**Addendum - Six**

**DOCTORS PARK**

**DATE OF ADDENDUM: March 01, 2016**

**PLUMBING:** Doctors Park – new restroom facility with attached pavilion

**1** FOUNDATION PLUMBING PLAN  
1/4" = 1'-0"

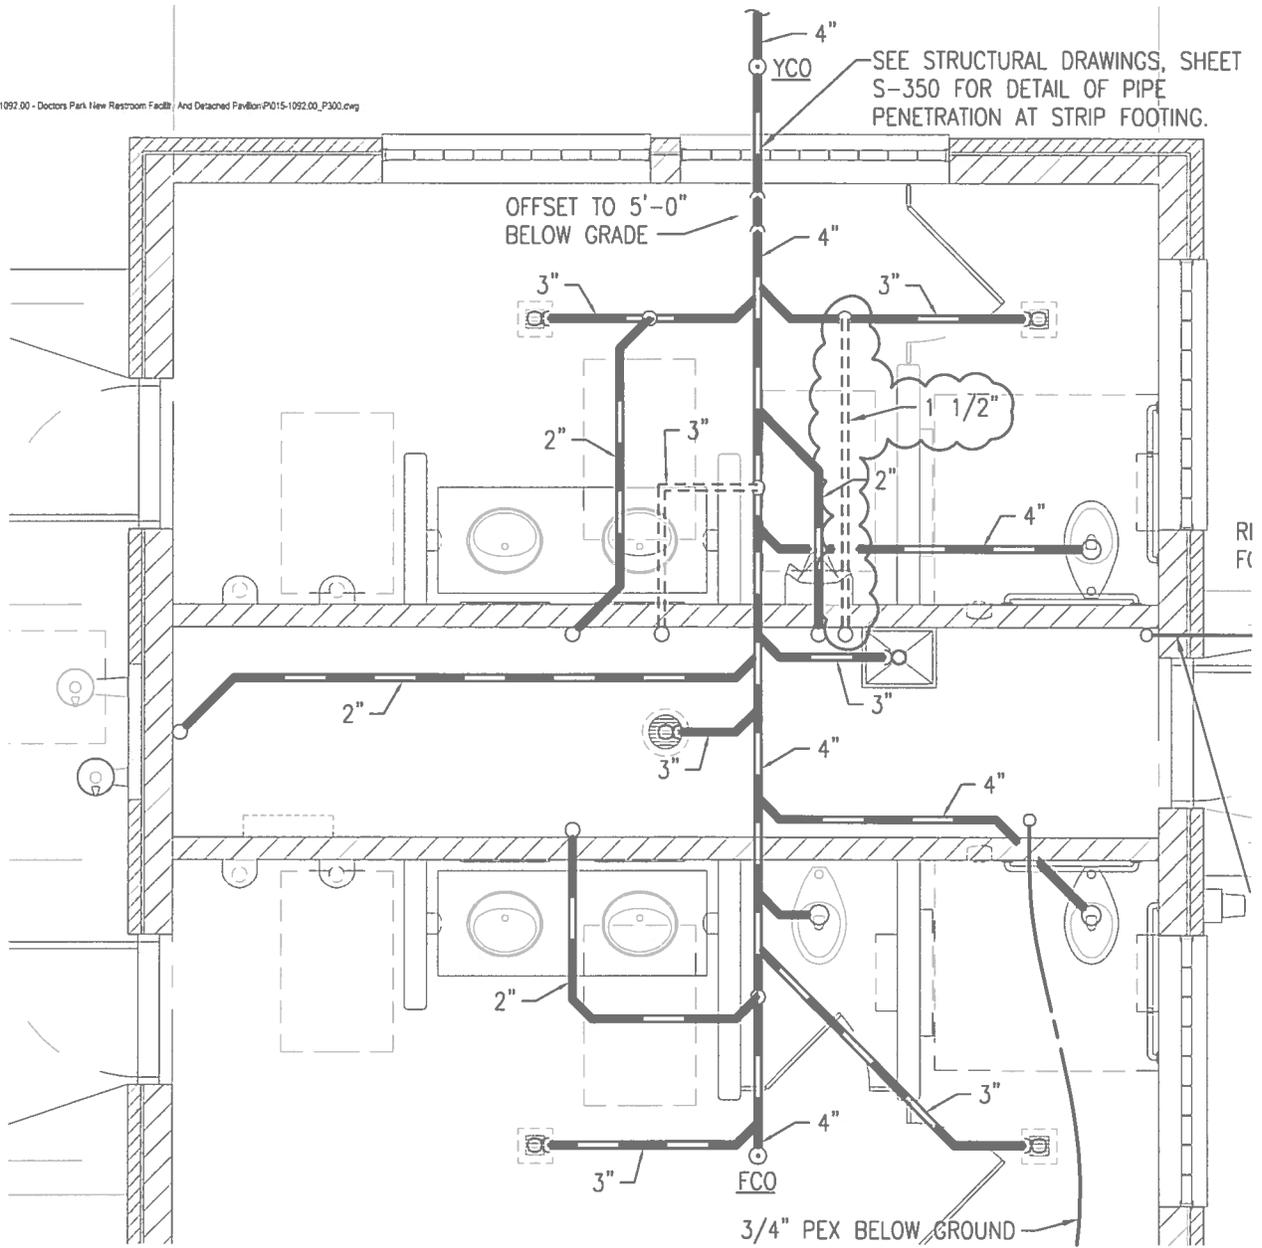
Revise: Foundation Plumbing Plan

Add 1-1/2 inch diameter sanitary vent piping below grade as indicated on attached sheet P-1.

**1 WASTE & VENT PIPING ISOMETRIC**  
NTS

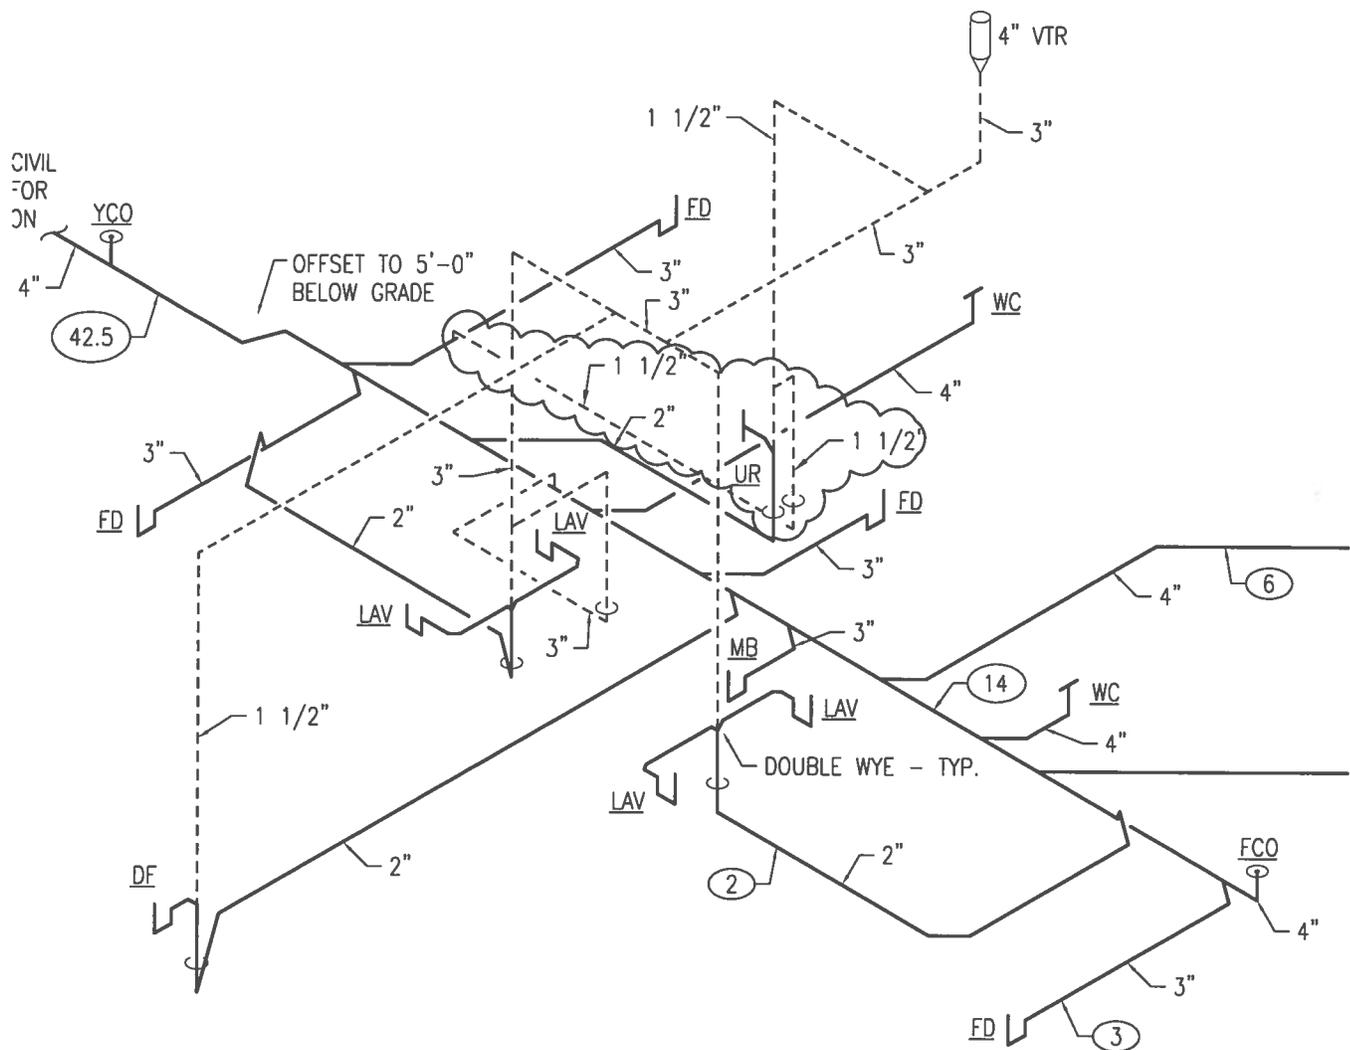
Revise: Waste & Vent Piping Isometric

Add 1-1/2 inch diameter sanitary vent piping below grade as indicated on attached sheet P-2.
